RS-10-094

Braidwood Station, Units 1 and 2
Facility Operating License Nos. NPF-72 and NPF-77
NRC Docket Nos. STN 50-456 and STN 50-457

Byron Station, Units 1 and 2
Facility Operating License Nos. NPF-37 and NPF-66
NRC Docket Nos. STN 50-454 and STN 50-455

Subject: Additional Information Supporting License Amendment Request to Change Fire Protection Program Requirements for Upper Cable Spreading Rooms

Figure: Typical UCSR Cable Riser Floor Seal

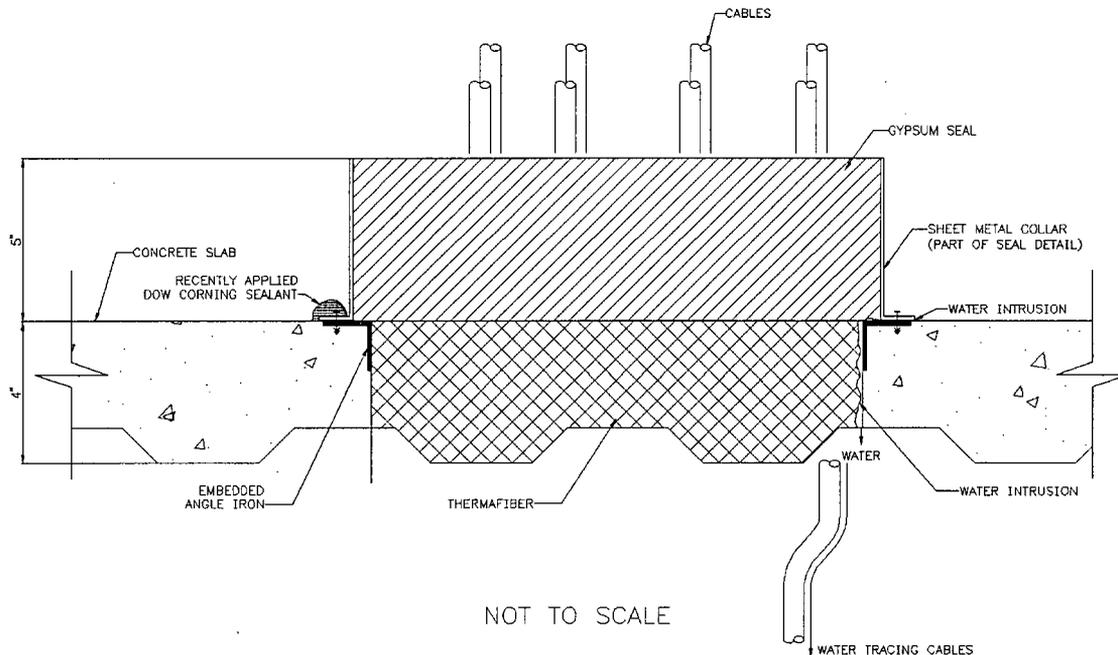
Provide an analysis of the impact of using firefighting water in the UCSR in light of the design of the UCSR floor fire seals, or justify why such an analysis is not necessary.

The configuration of a typical cable riser floor fire seal in the UCSRs is shown in the figure below. The configuration of the subject fire seals consists of a 5" high, 18 gauge, sheet metal collar anchored to the floor surrounding the floor opening. The collars are approximately 1" to 2" longer and wider than the opening, creating a horizontal overlap between the gypsum and the concrete. During installation, damming material was installed inside the opening below the collar, and the gypsum material was then poured into the collar, starting flush with the surface of the concrete floor, overlapping the concrete horizontally approximately 1" to 2" around the perimeter of the seal, and rising up within the collar to form a seal around the penetrating items. The installed gypsum overlaps the opening on each side, but does not extend below the top surface of the floor into the opening.

The seals have been qualified as 3-hour fire seals per IEEE 634, "Standard Cable-Penetration Fire Stop Qualification Test," and ASTM E119, "Standard Test Methods for Fire Tests of Building Construction and Materials." The fire seal testing included multiple hose stream tests per ASTM E119, which verified that a hose stream would not dislodge a fire seal and would not project water beyond the unexposed surface of the fire seal. Note that these fire seals are also rated as ventilation seals; however, these seals do not have a flood seal rating.

Flood-rated seals were not installed in this application since the UCSR elevation 463'-5" floor is not designed as a flood rated barrier. This is due to the only source of water being the Fire Protection piping to the installed hose stations. The probability of failure of this system is considered low since it is a low pressure system not subject to transients. Flood calculations performed for each of the UCSR compartments show that the floor drains are sized for expected releases or in-flow of water to the area without significant buildup of standing water. The calculated height (i.e., less than two inches) is less than the height of the metal collars surrounding the penetrations; therefore, leakage is not expected.

A potential leak path for the standing water would be through the interface between the collars and the floor. However, actions are being taken to caulk this interface to address the concern about water leakage through the collar/floor interface. Since water levels above the top of the curbed openings or fire barrier collars are not expected, the caulked fire/ventilation seal configuration will be sufficient to prevent potential water intrusion/leakage events during normal plant operation (i.e., postulated line breaks or hose station leakage) and during fire fighting conditions where water spray may be used.

Given the actions to verify the proper operation of the floor drain systems and to caulk leakage points at the floor-seal interfaces, as well as ASTM E119 qualification testing that demonstrates the installed seals will not project hose stream water to the cold side of the seal, potential mechanisms for leakage of water through the seals have been addressed. Therefore, an analysis of the impact of using firefighting water in the UCSR in light of the design of the UCSR floor fire seals is not necessary.
